**ADDENDUM
NO. 3**

September 11, 2024

**LOGANSFORT JR. HIGH SCHOOL RENOVATIONS
Logansport, IN 46947**

GIBALTAR DESIGN SHEET
C EP103

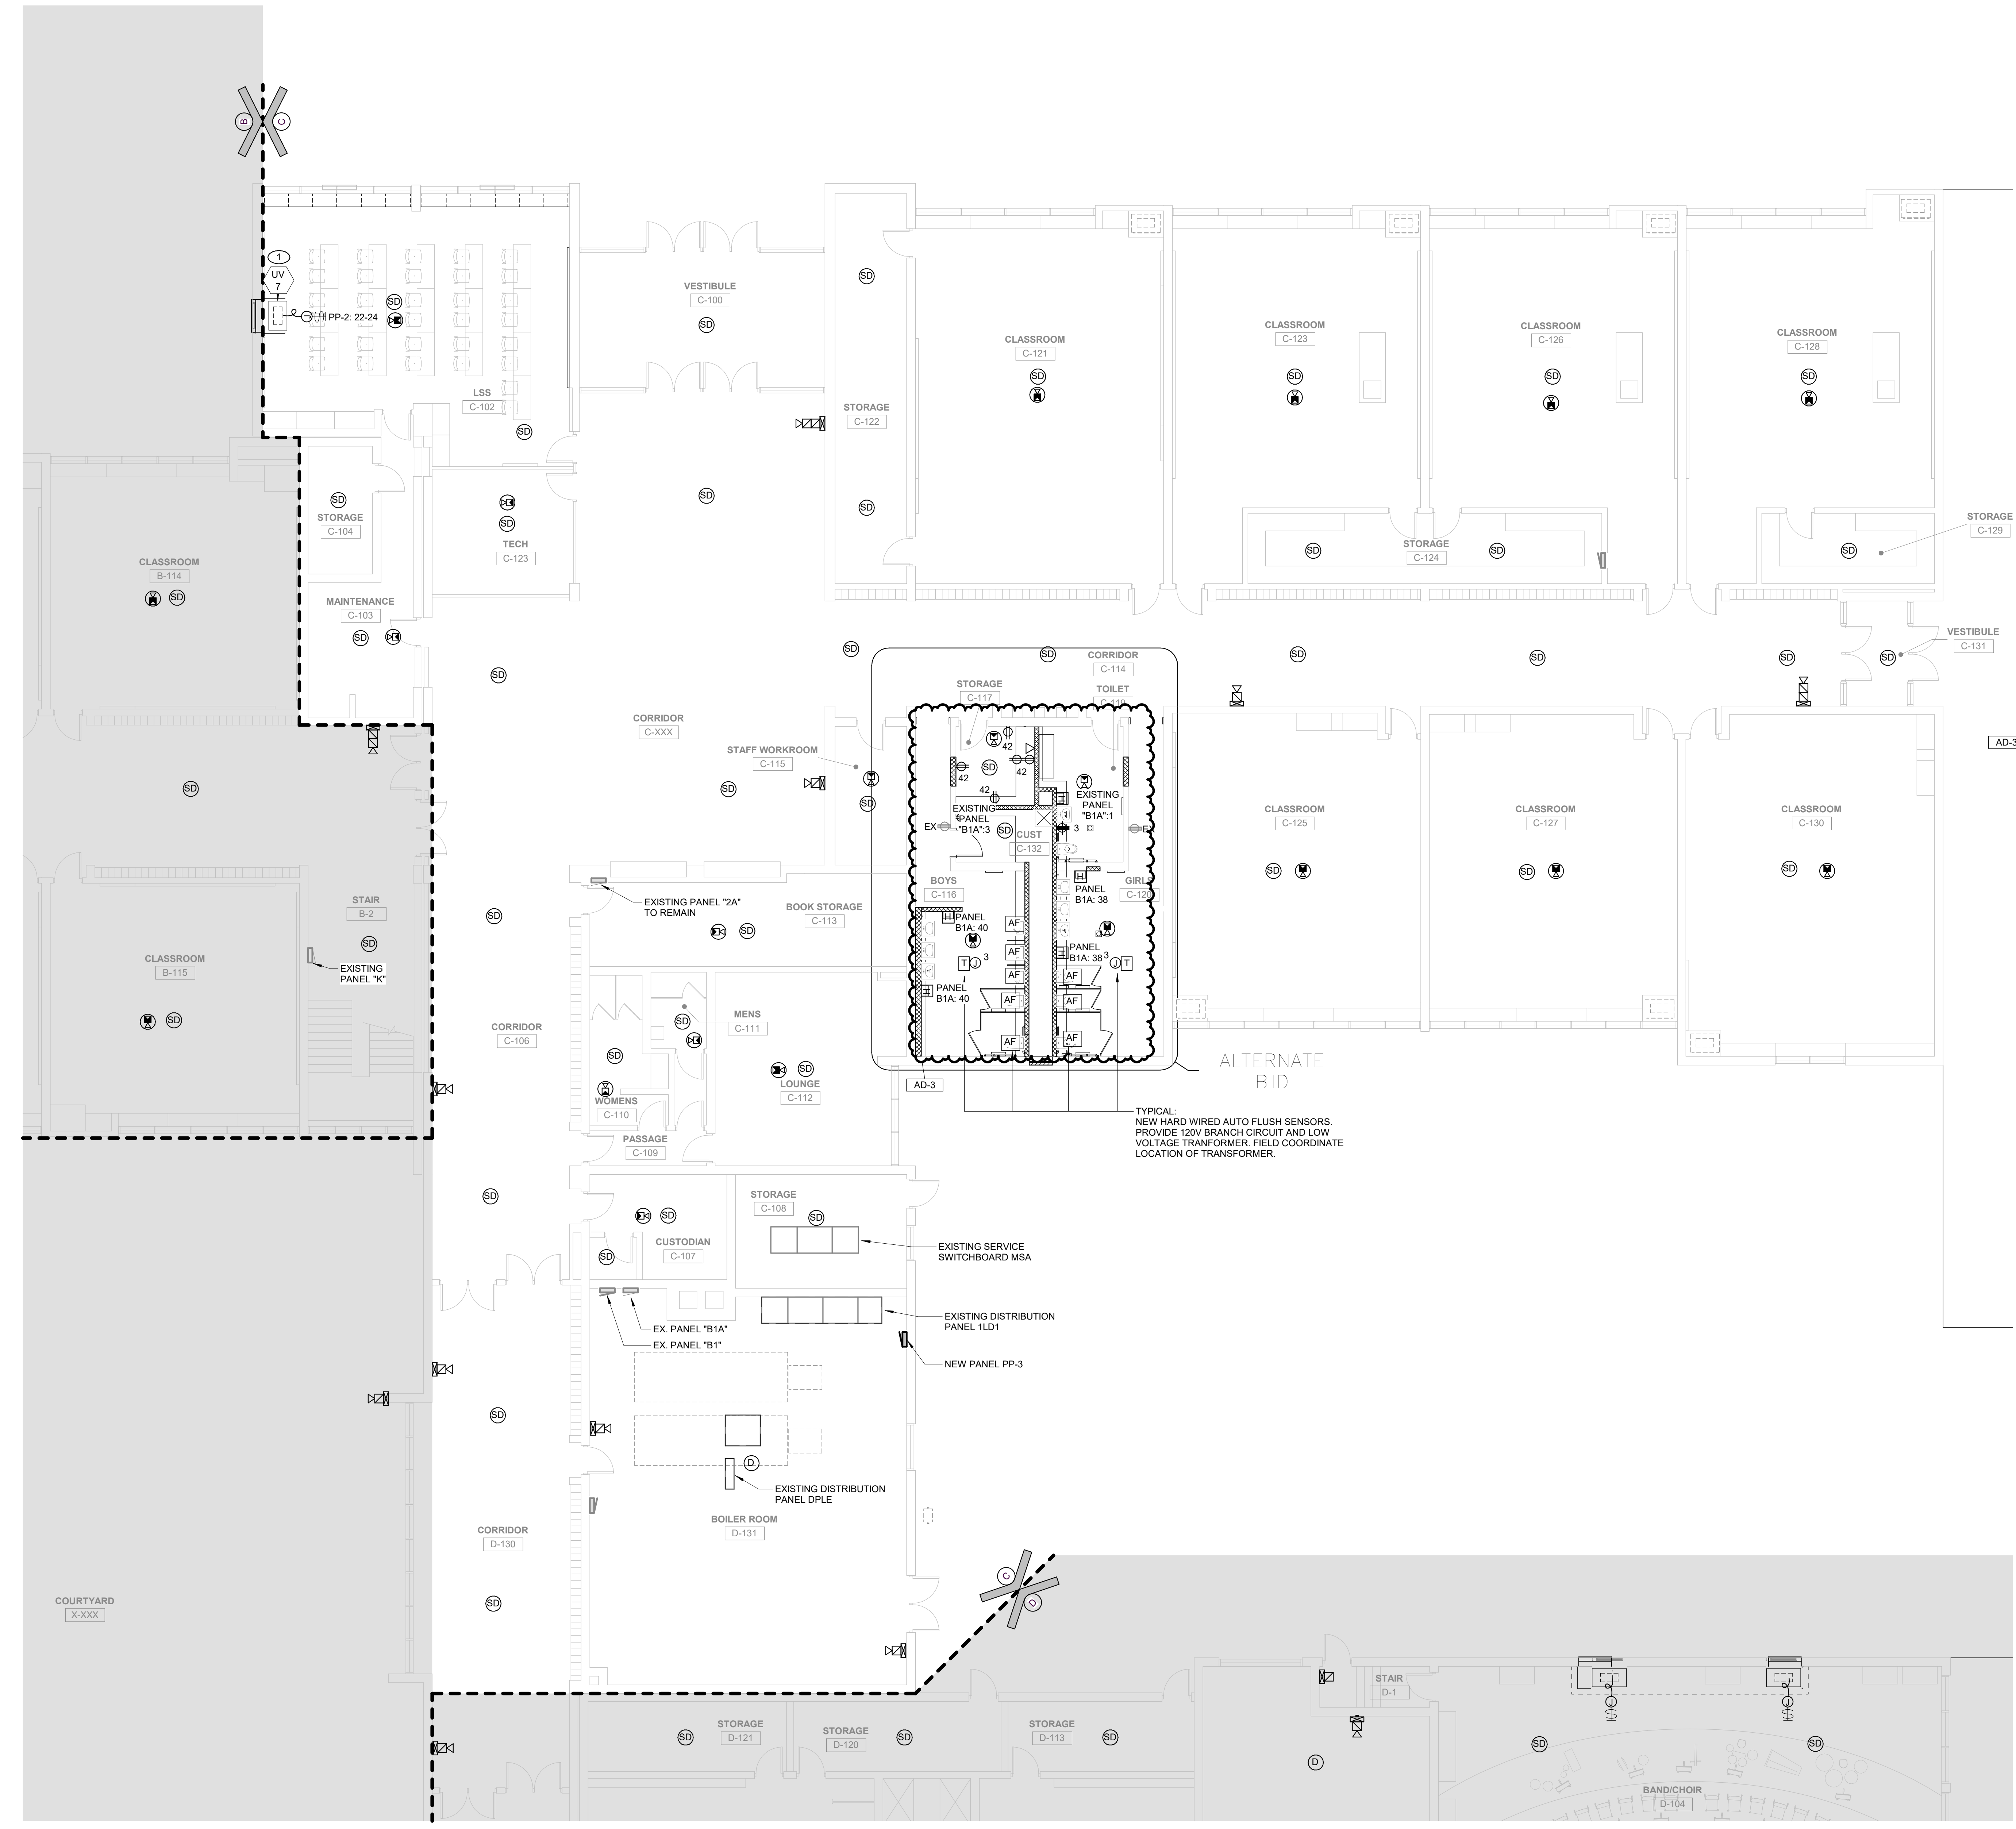
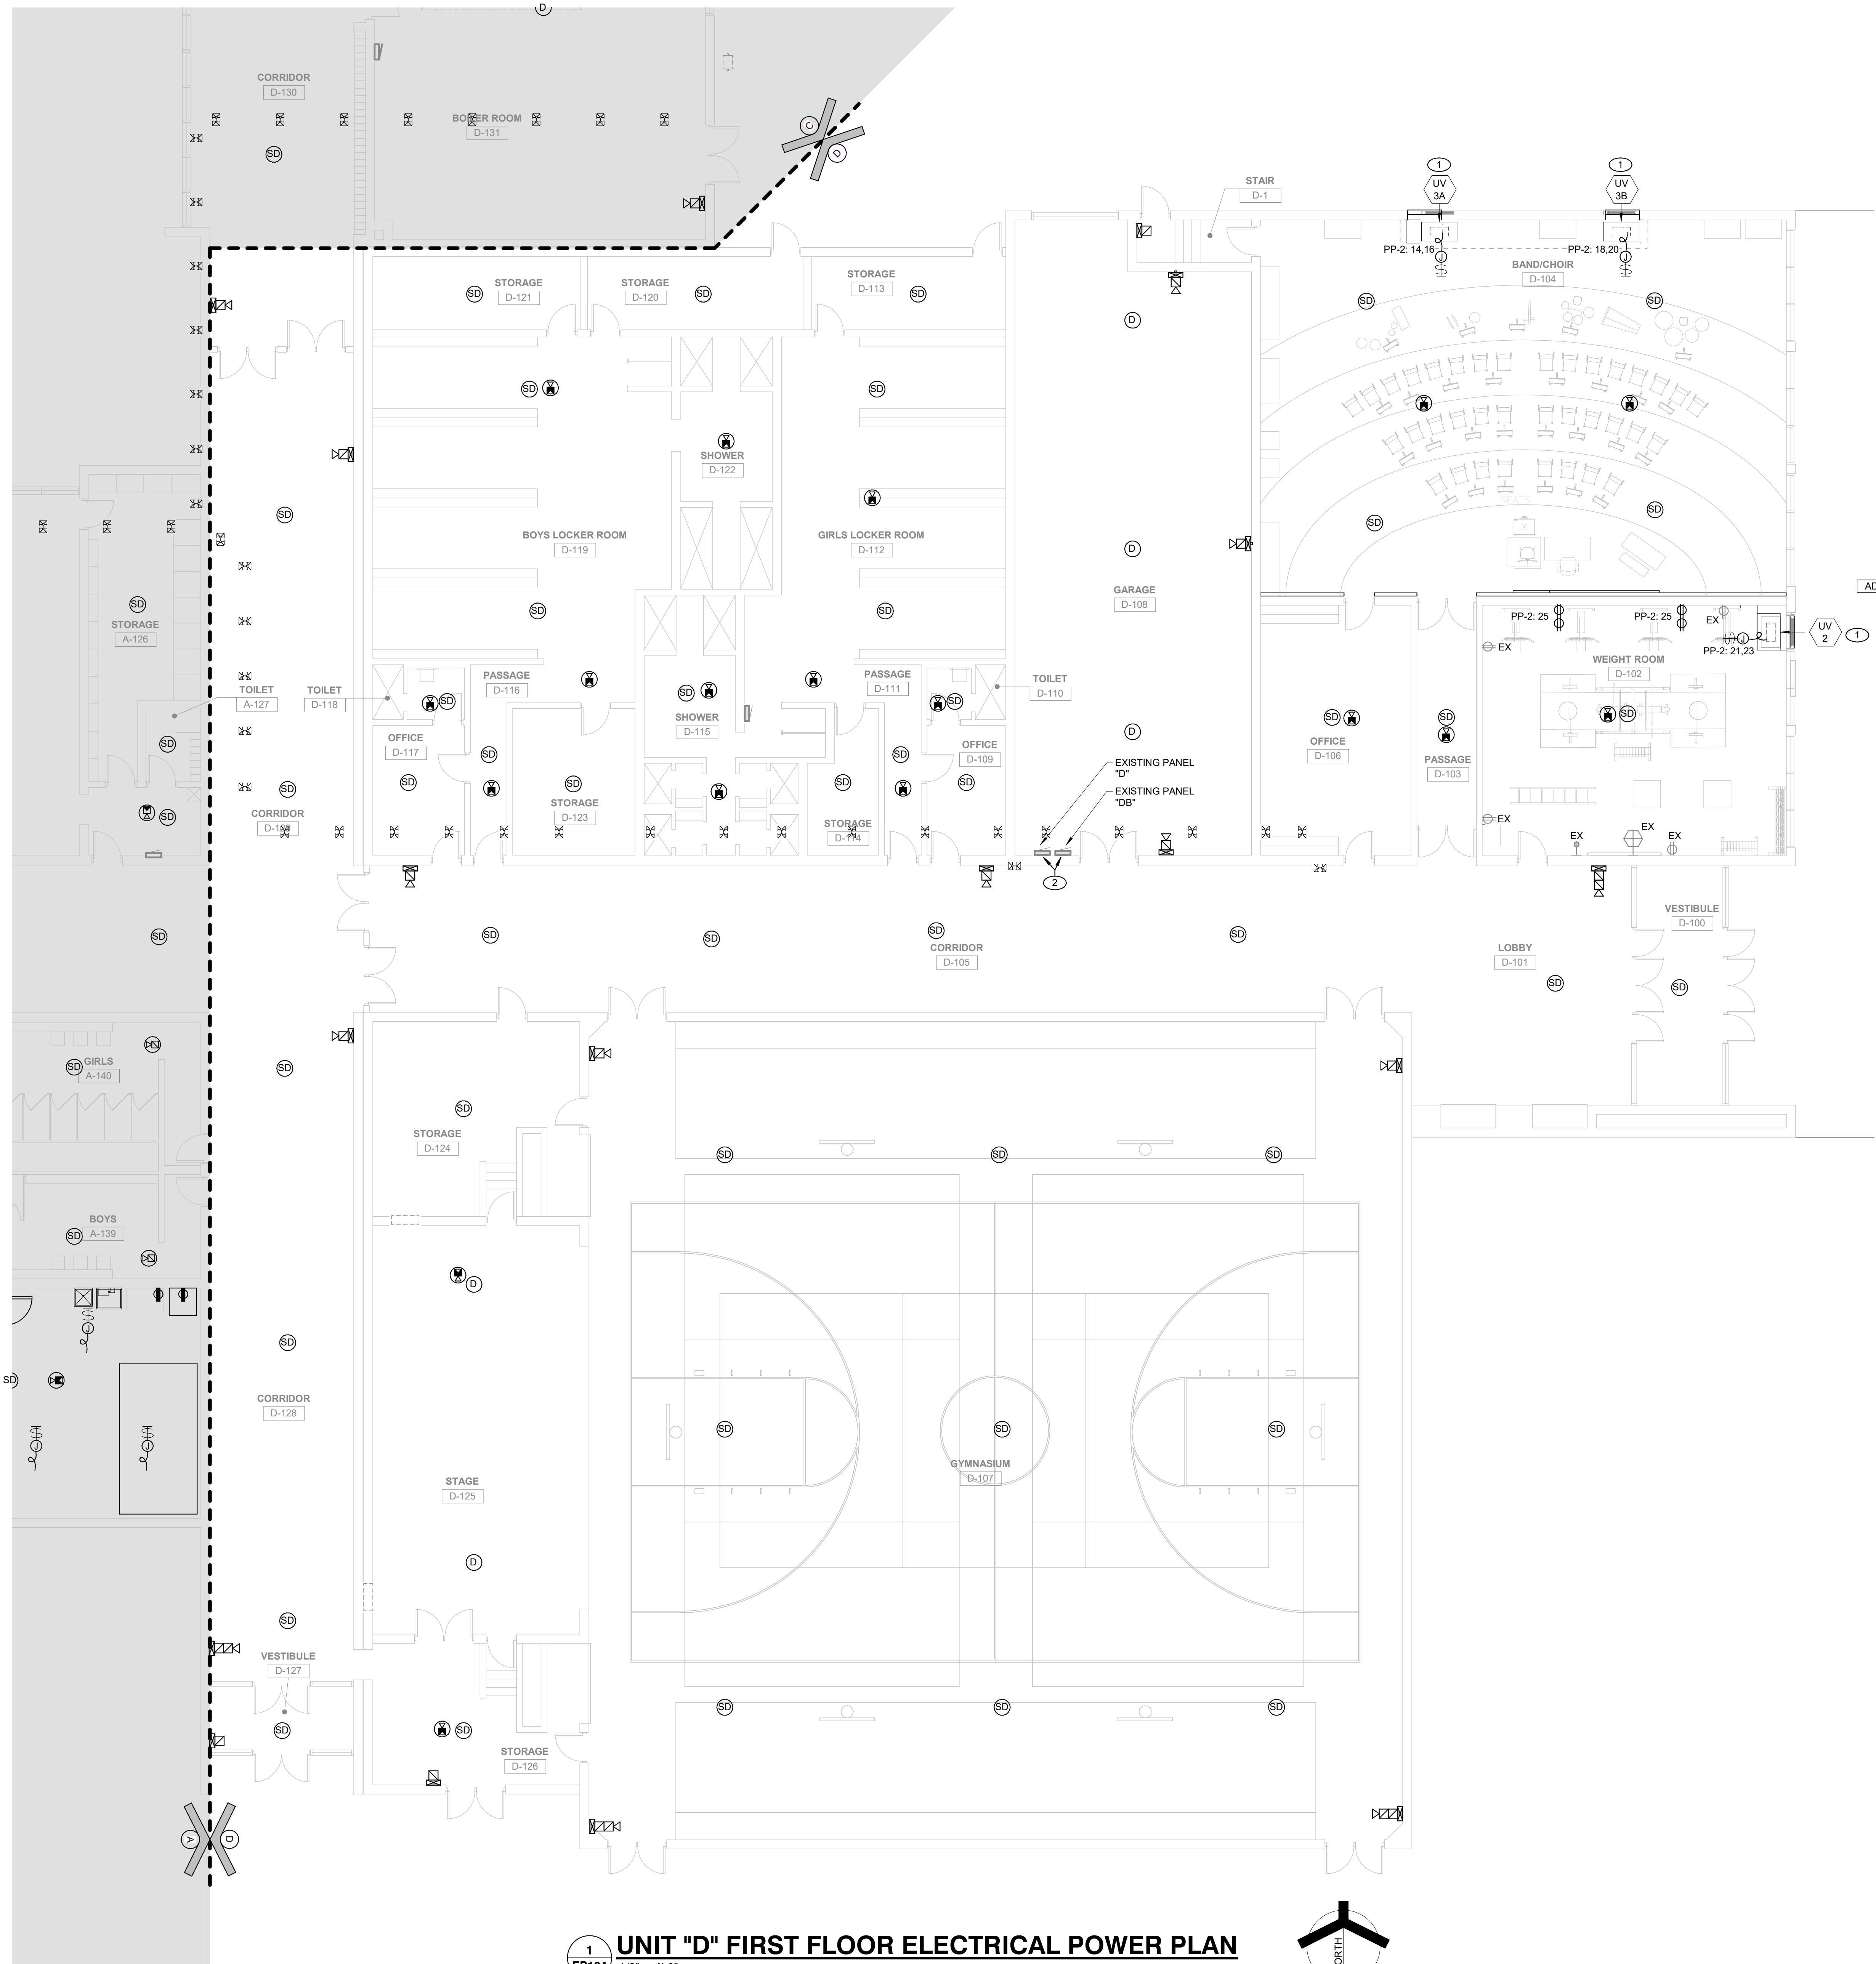
- A. Added low voltage scope.
- B. Added Alternate Bid to toilets including Storage C-117.

© GIBRALTAR DESIGN
SHEET
D EP203

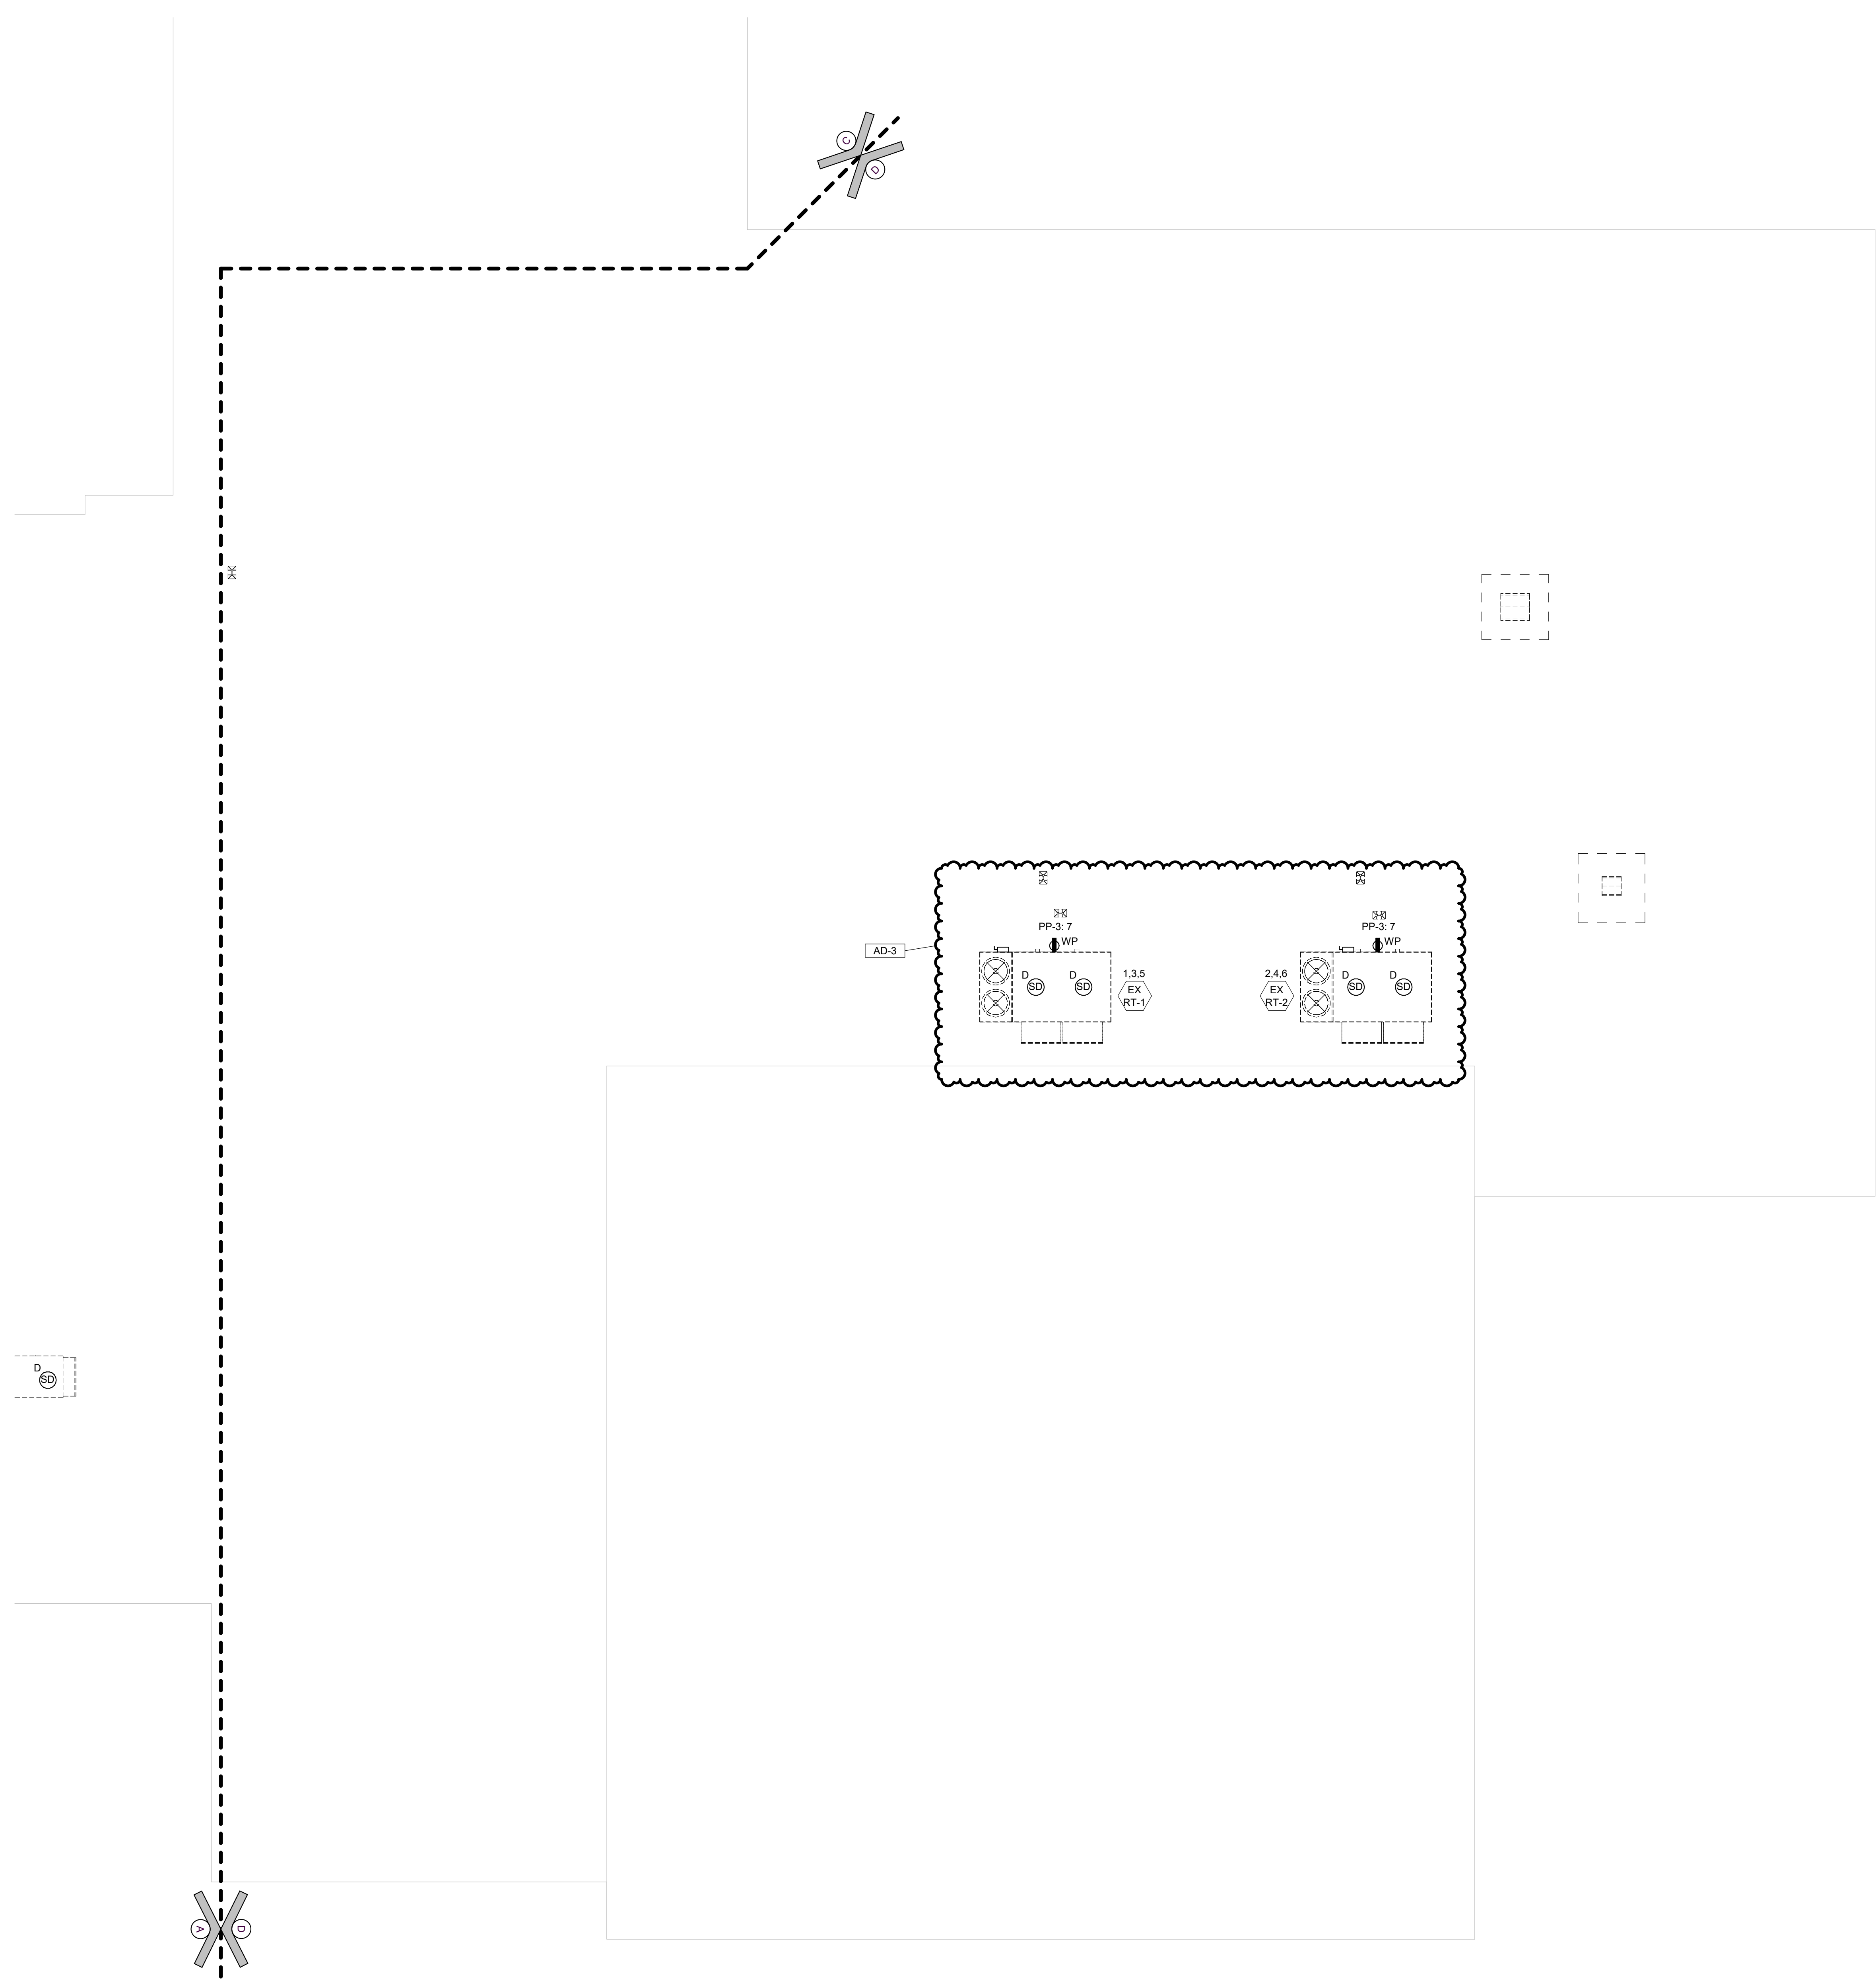
- A. Added (2) duct smoke detectors at each EX RT-1 and EX RT-2.
